RECEIPT DATE: 10/24/19 **ONSITE SEWAGE DISPOSAL SYSTEM** P 56648

RE: 12225 Hayland Farm Way, Walnut Creek Lot 161, OSDS Design Plan comments

LOT 161
SEPTIC SYSTEM
INSTALLATION SITE PLAN
WALNUT CREEK
PHASE THREE

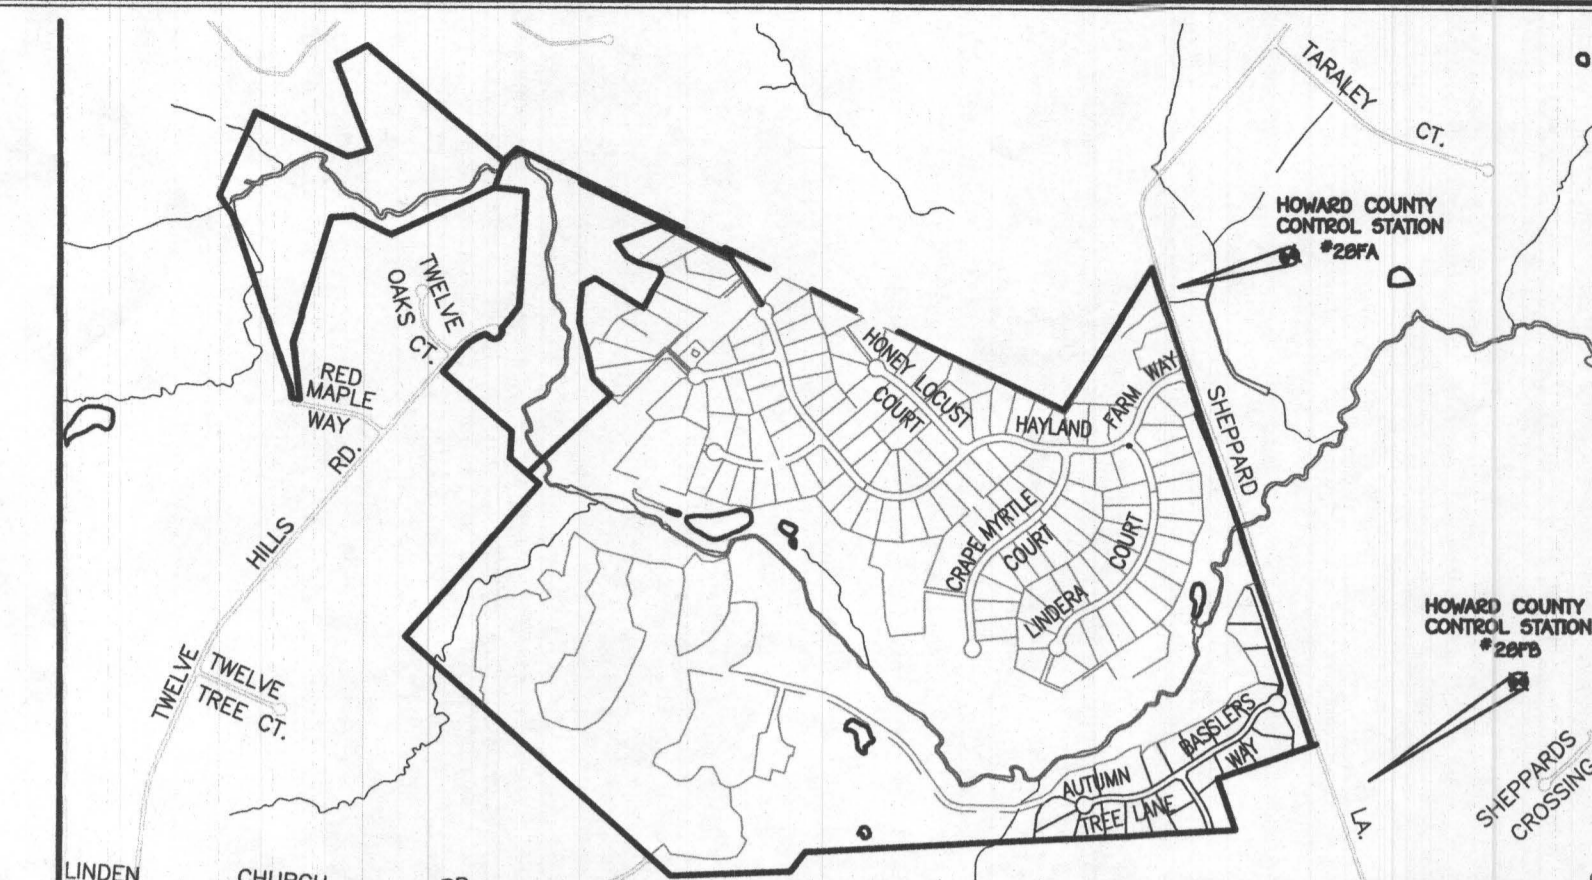
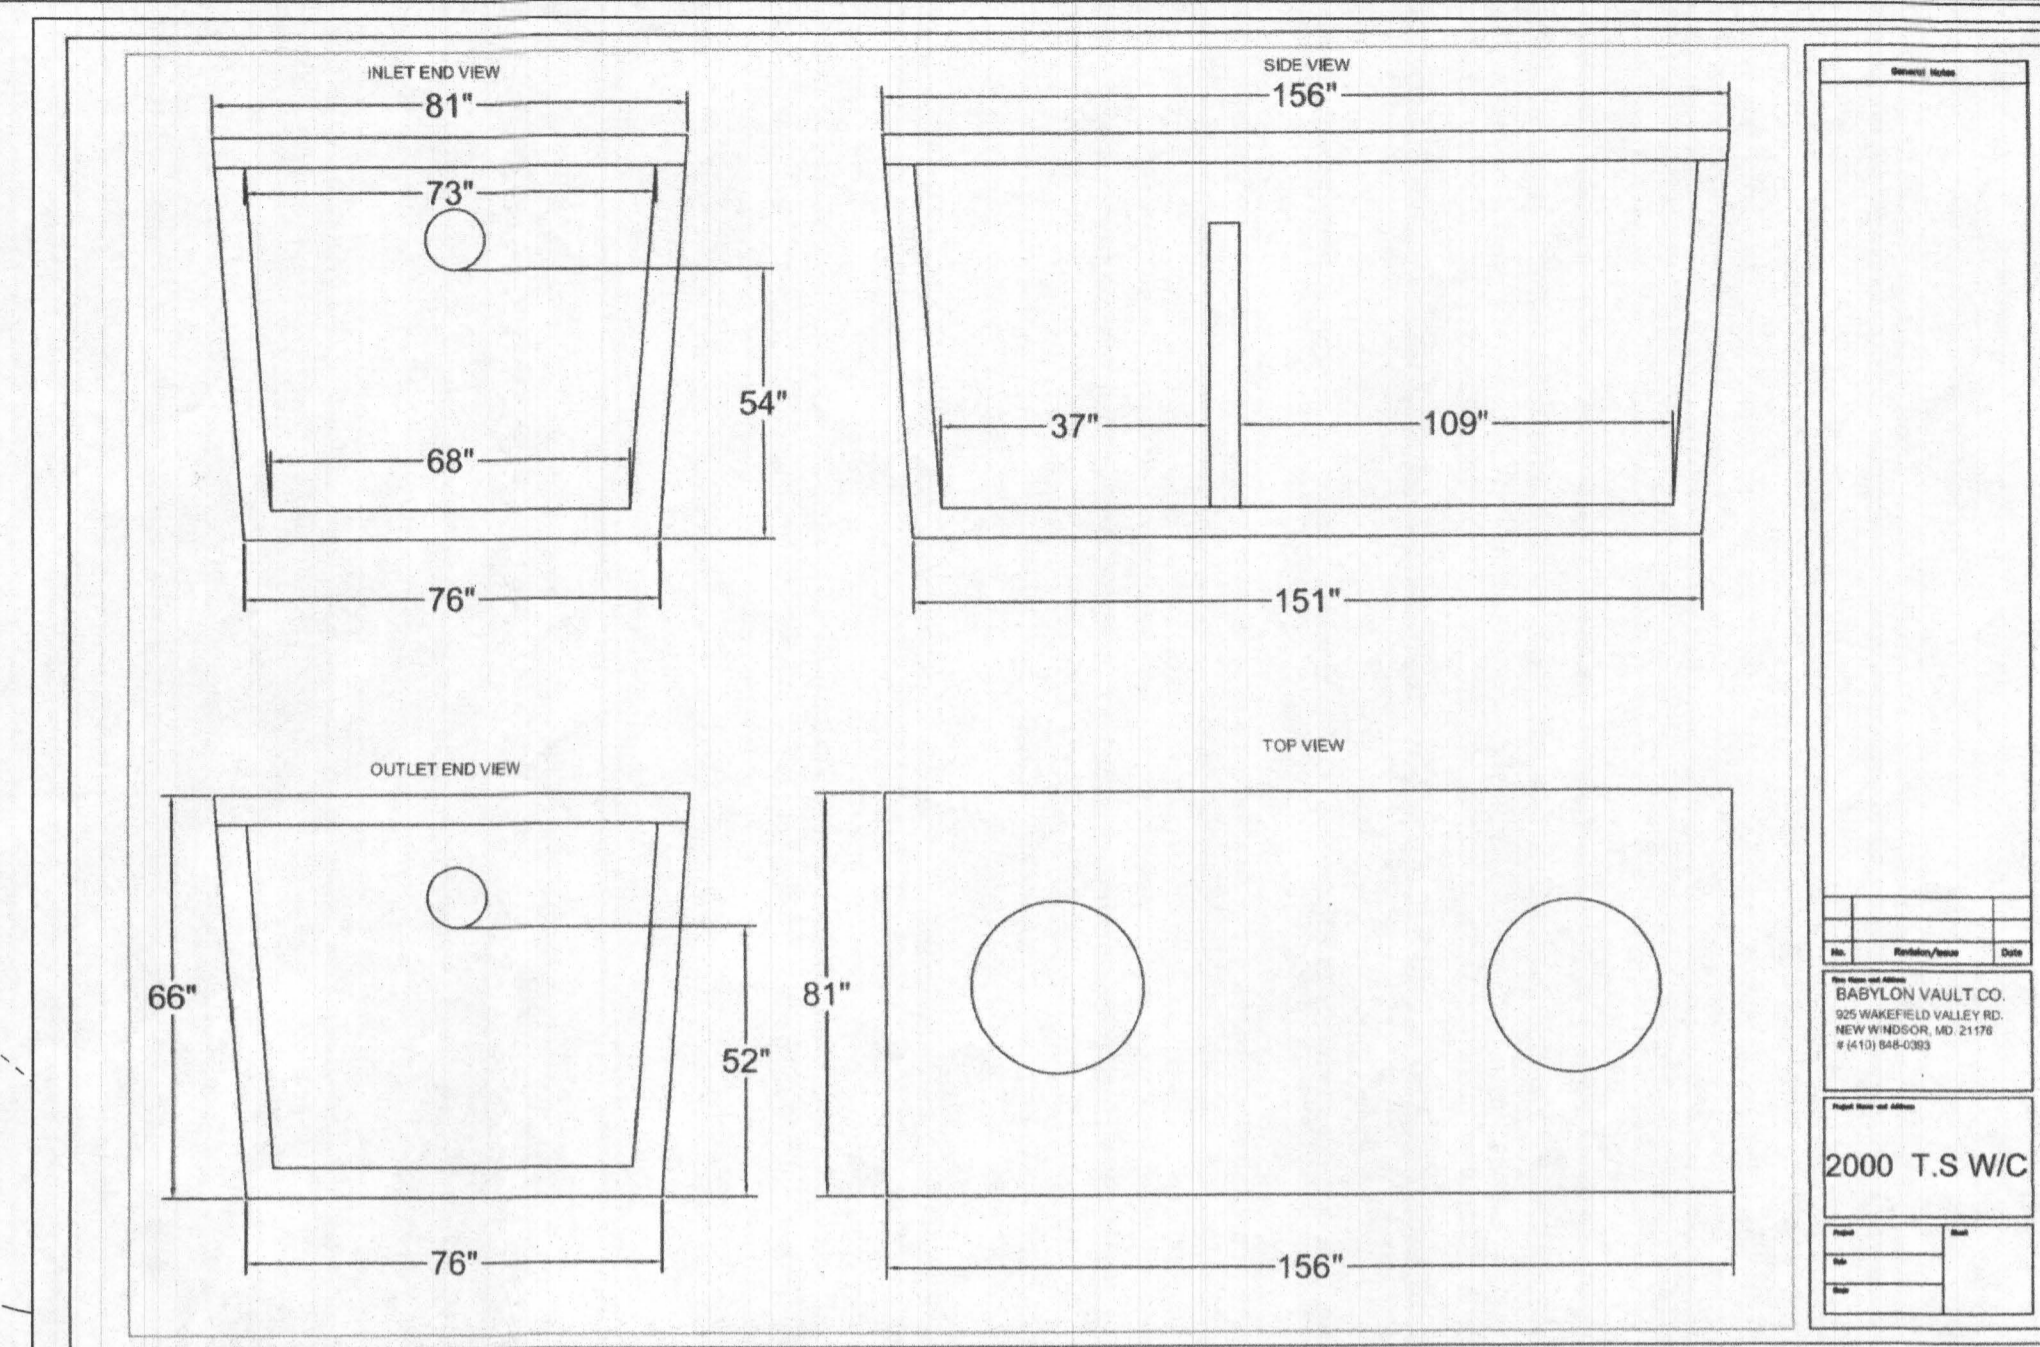
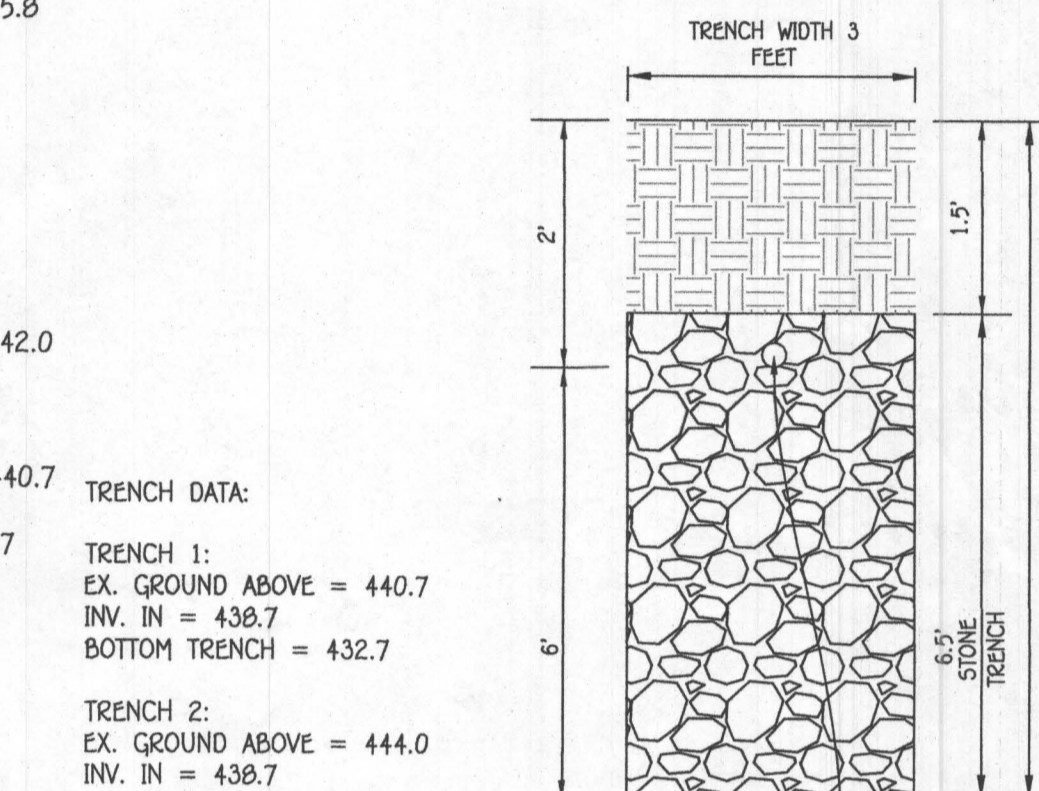
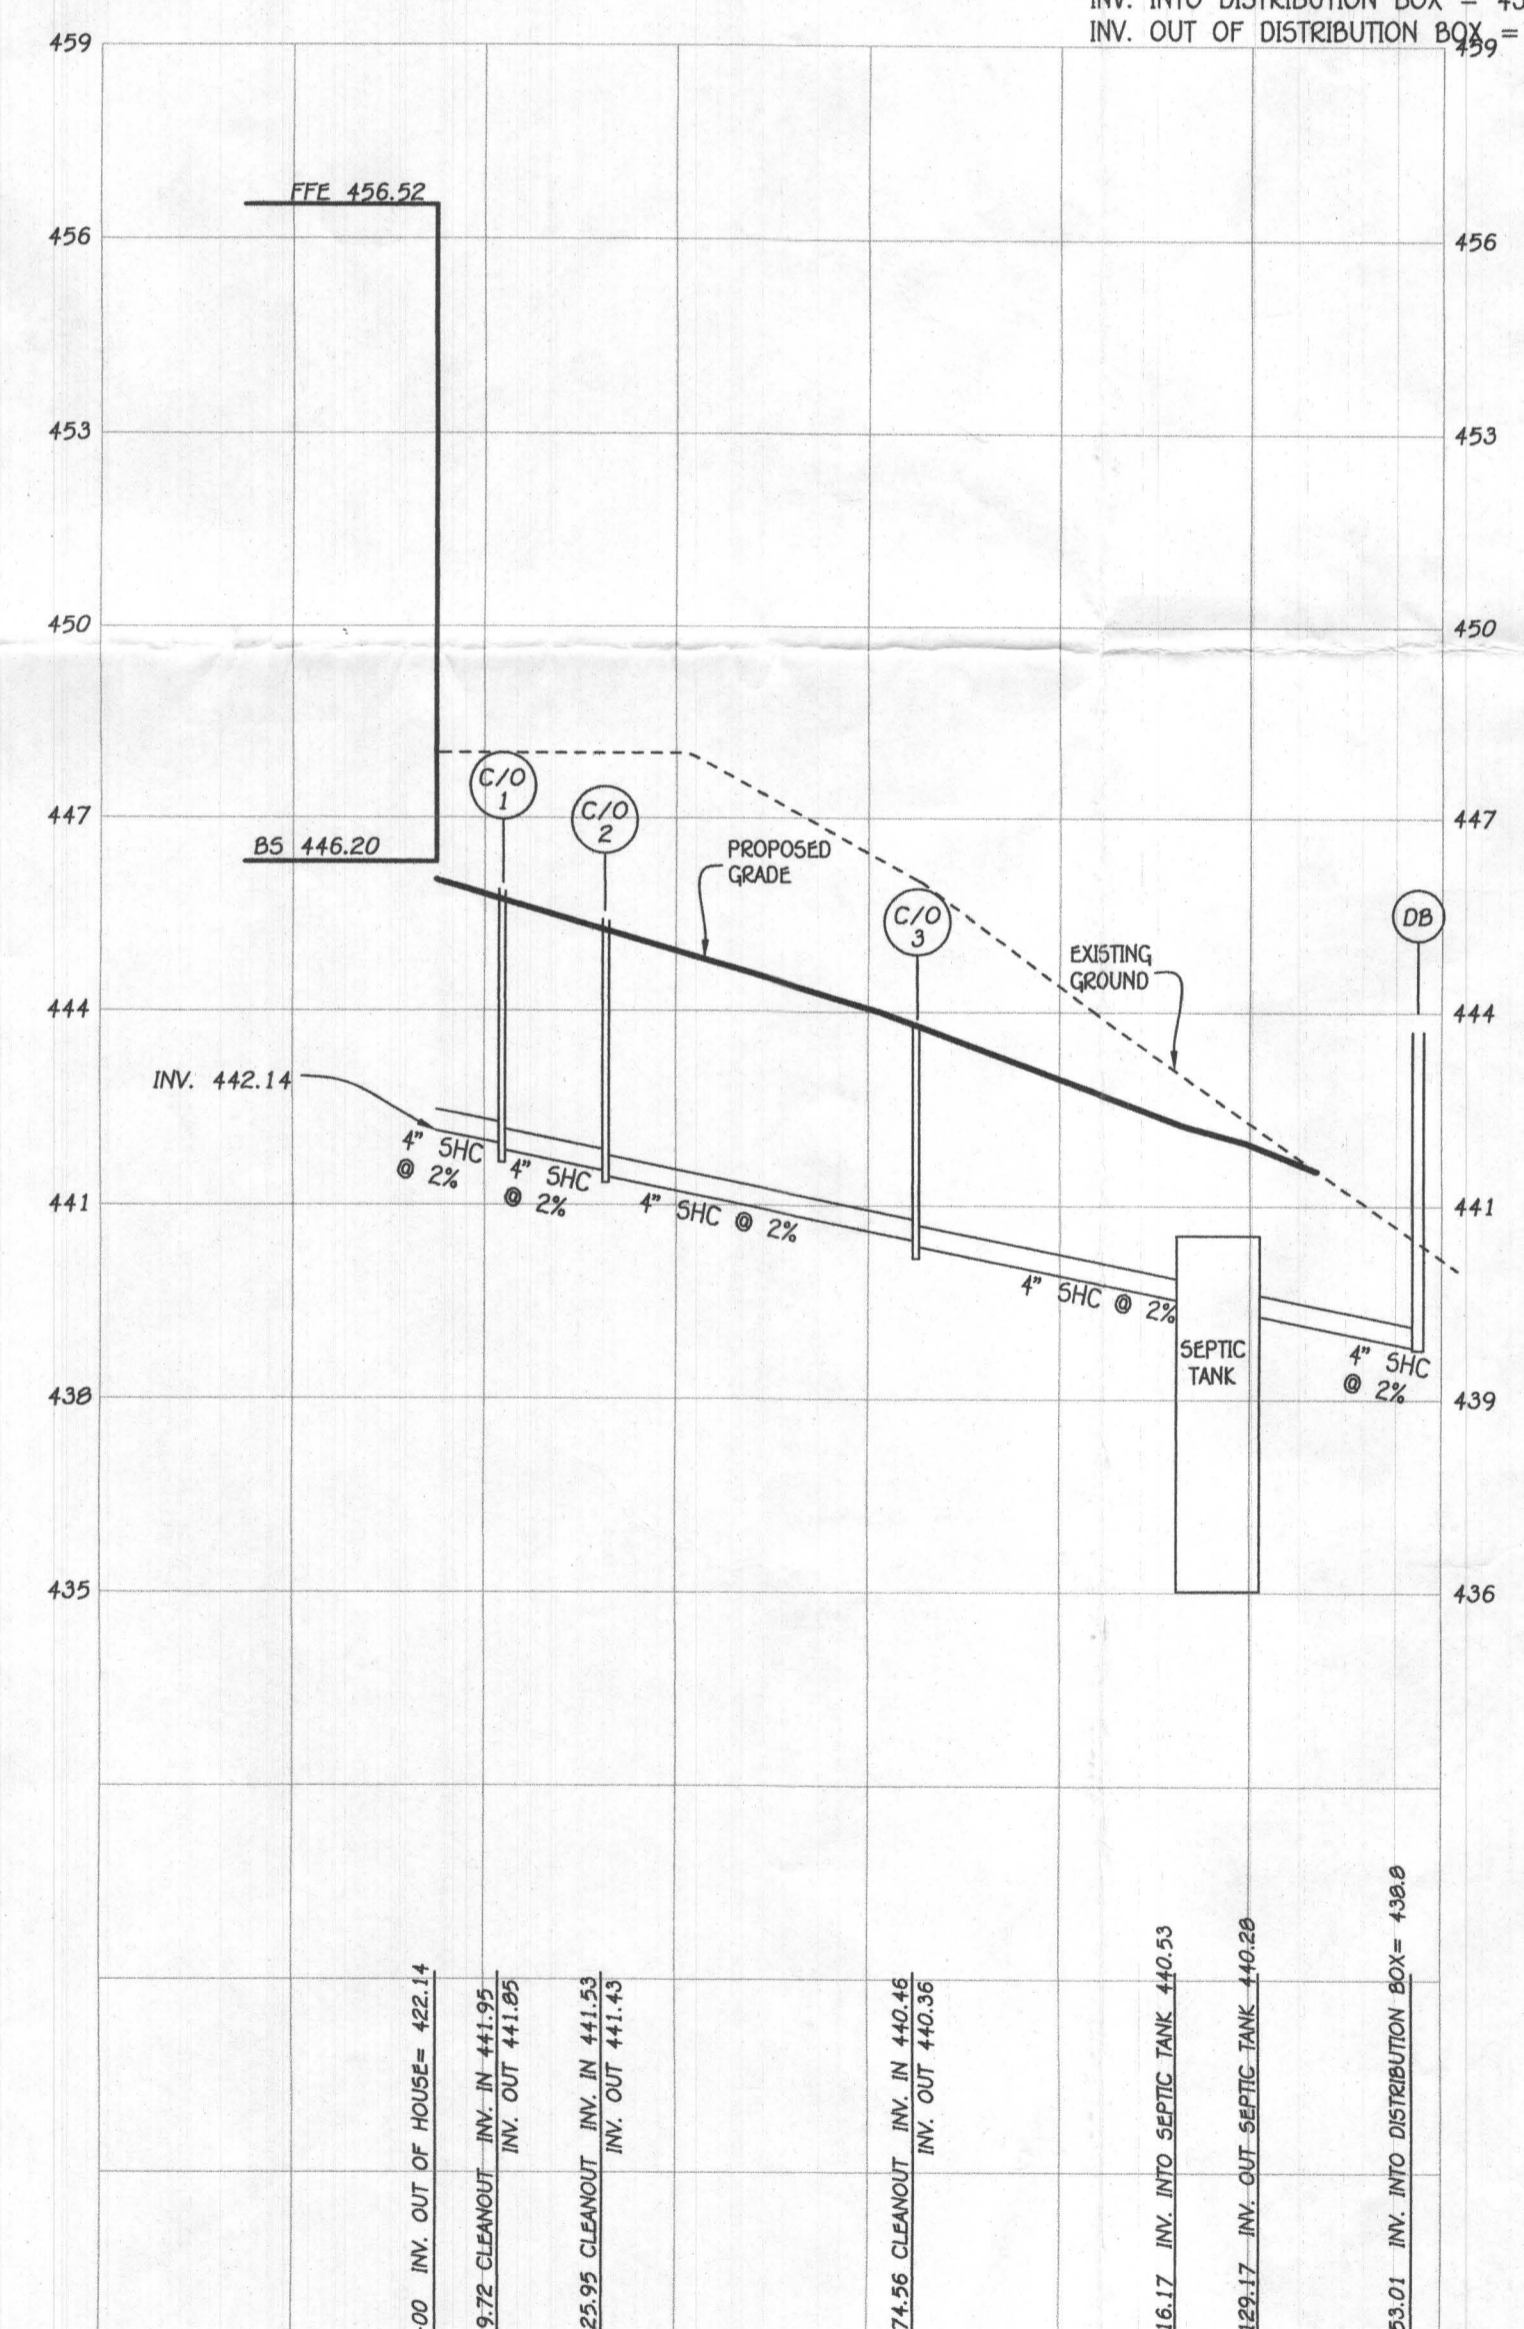
1. The septic tank is proposed against the upper boundary of the sewage disposal area.
 - a. Shift the septic tank location about 5 feet or so uphill.
 - b. Shift the Initial System trenches uphill several feet so that a portion of the upper trench is against the SDA boundary
2. The driveway encroaches on the 10-ft setback from the well zone, and the driveway is only about 8 to 9 feet from the existing well.
 - a. Typically, a revision of the Percolation Certification Plan is required to re-configure the well zone
 - b. The driveway should be moved enough to create a 10-ft setback to the existing well.
 - c. You may request to redline edit the current Percolation Certification Plan for Lot 161.
